FCC ID: R6Y-VM4SW

Power circuit please refer to V4RF 2014-12-14 V1.7 (1.Power).png

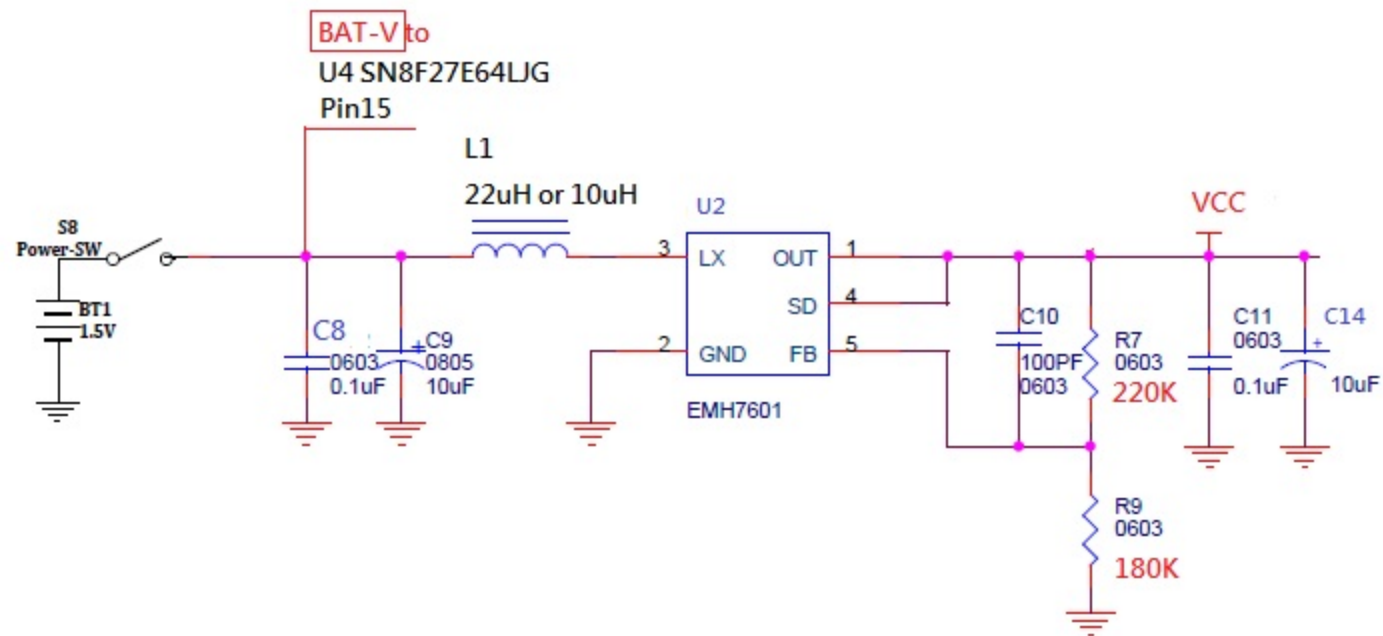
2014-11-13 Change Power IC into EMH7601 (Completed)
C9/C14 use Tantalum Capacitor

2014-12-15 modify:

1. Change R7/R9 value, Output is 2.65V
2. Change the net name as VCC

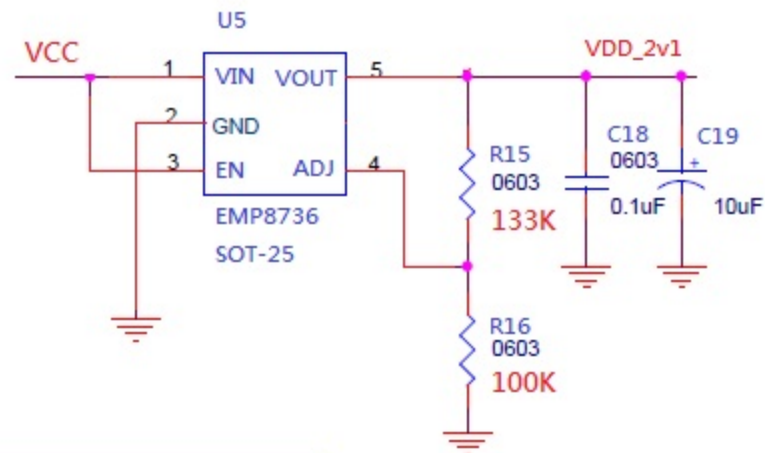
2014-12-15 add:

1. EMP8736 (SOT-25)
2. Input net VCC
3. Output net VDD_2v1

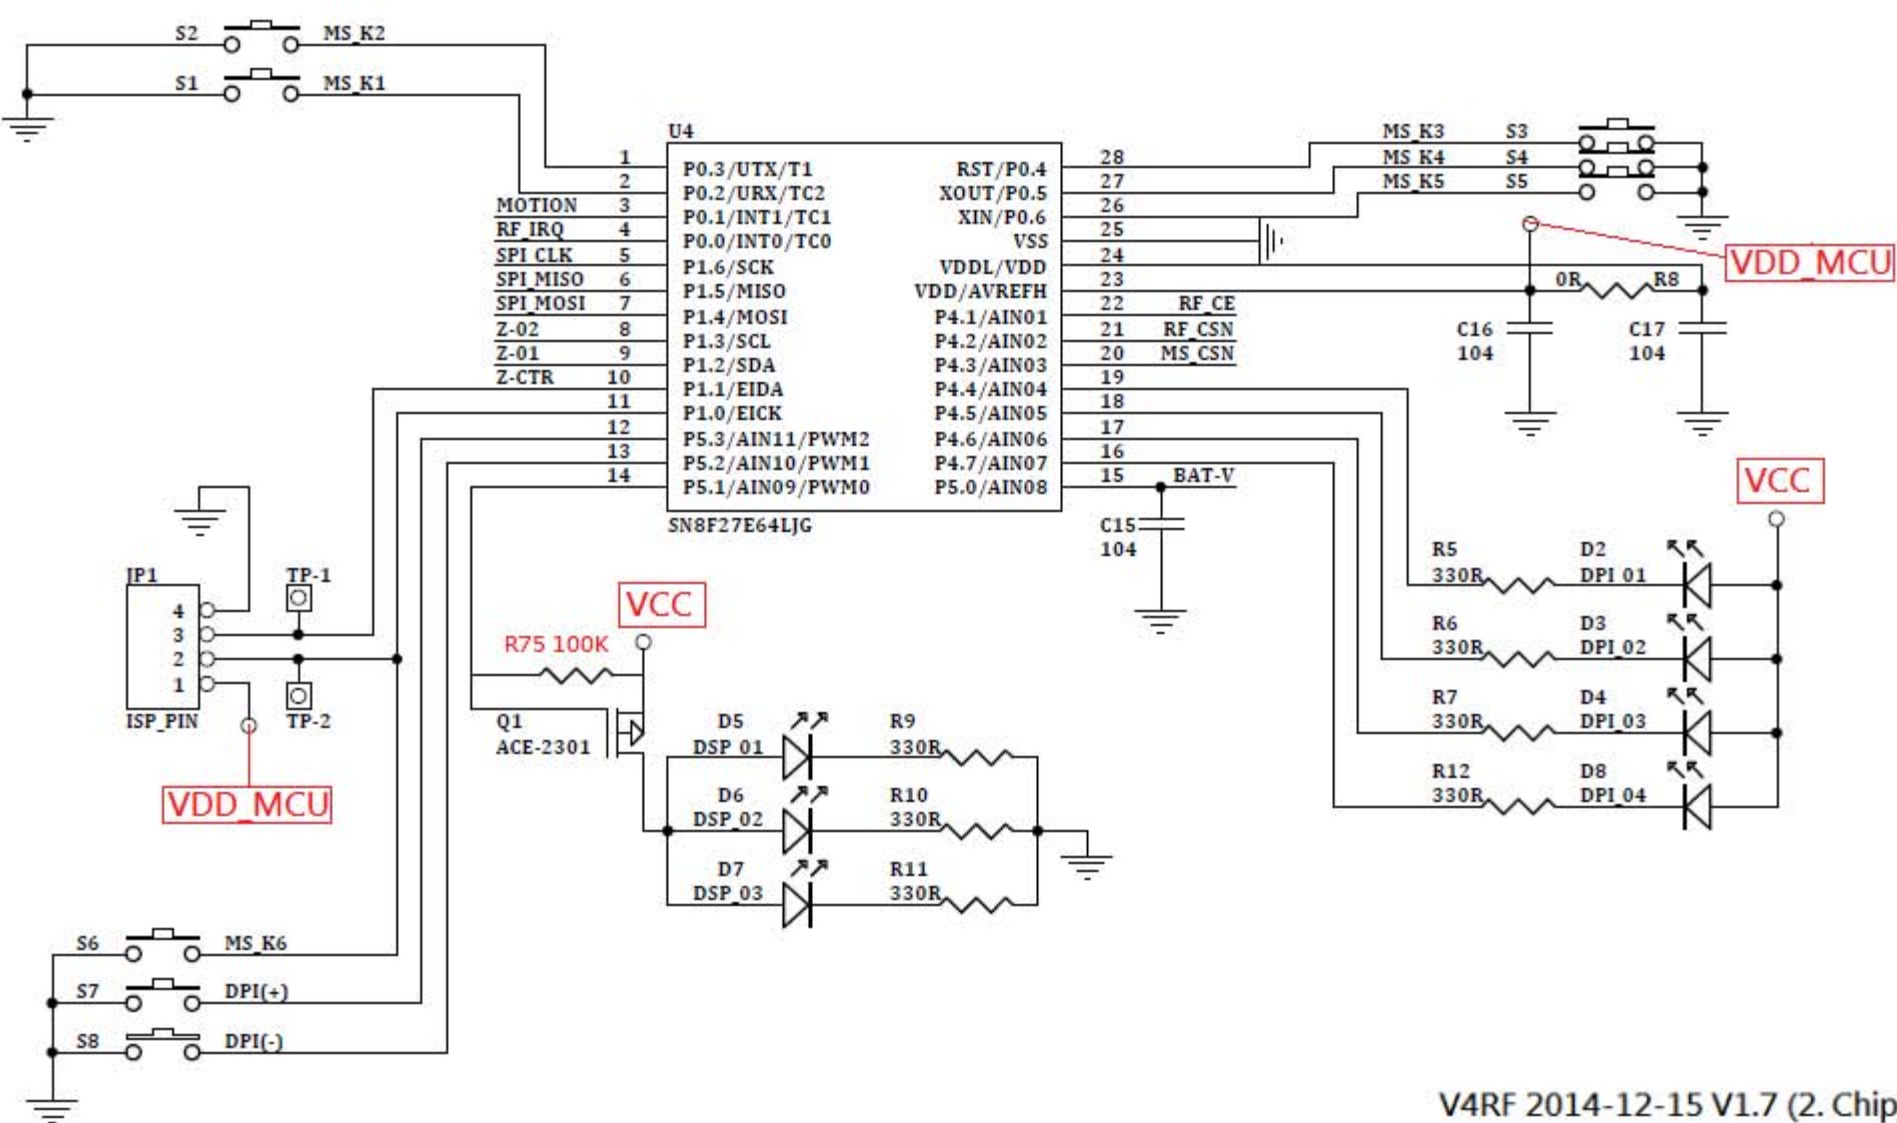
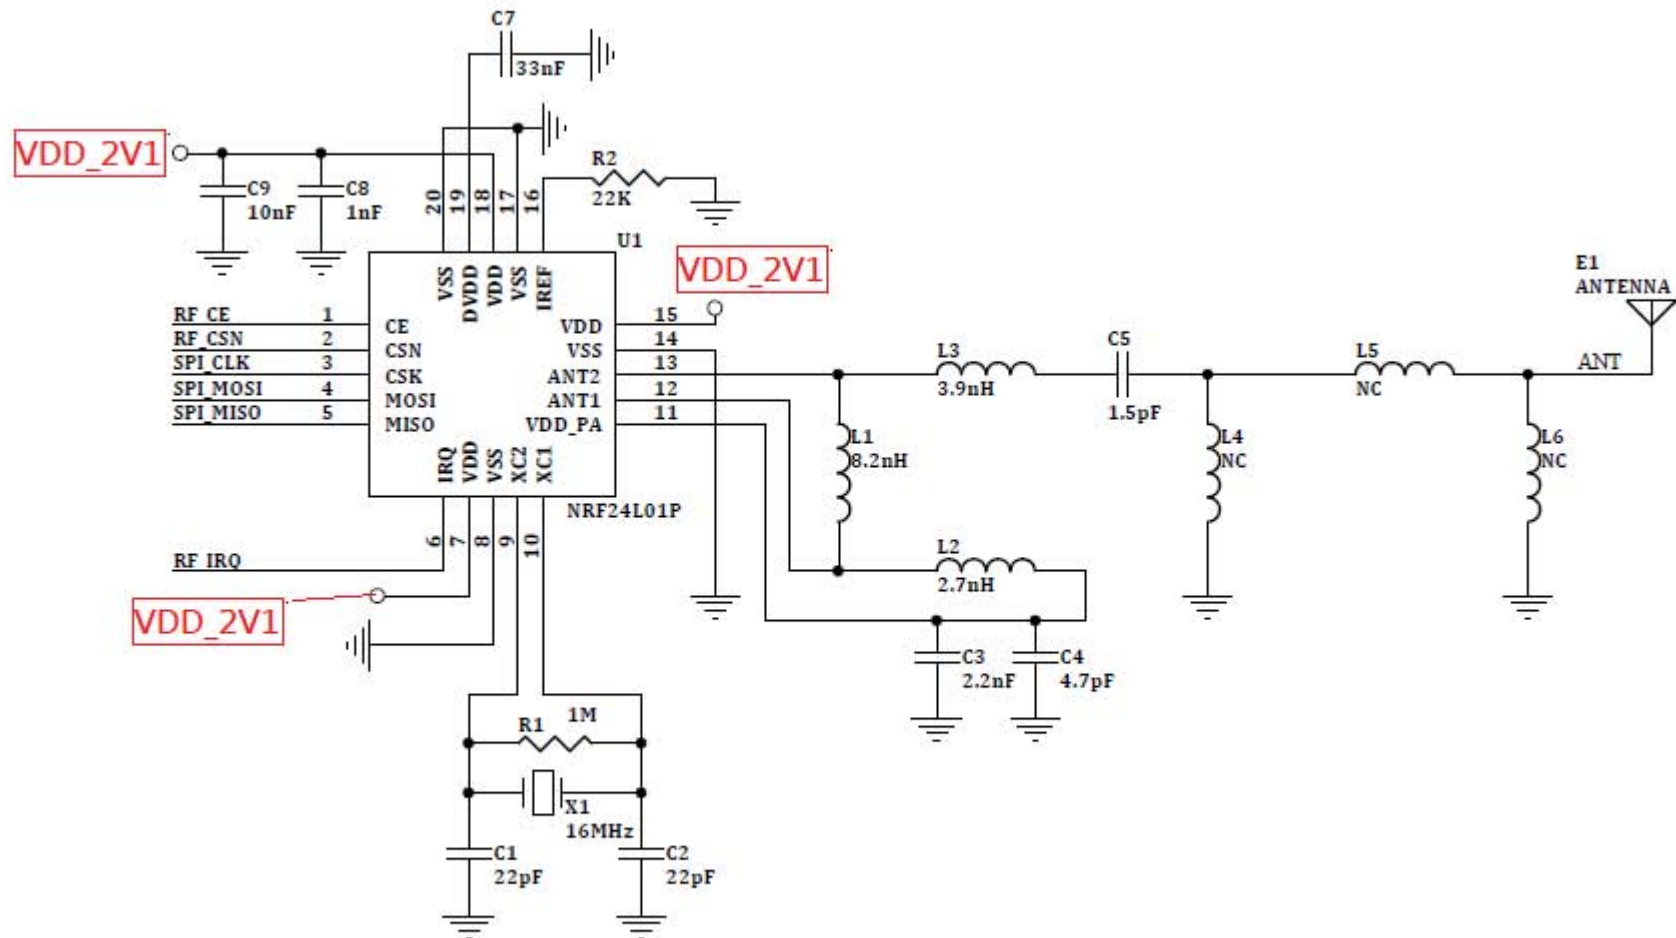
2014-12-15 add R77/R78 0 ohm

Default uses R78

ISP Dev. uses R77

2014-12-15

1. Add resistance R75 / R76

2. Modify resistance value R13 / R14

3. Modify the voltage net

U4 / JP1: VDD_MCU

Function LED: VCC

A3000 LED: VCC

U1 / U3 / Z: VDD_2v1
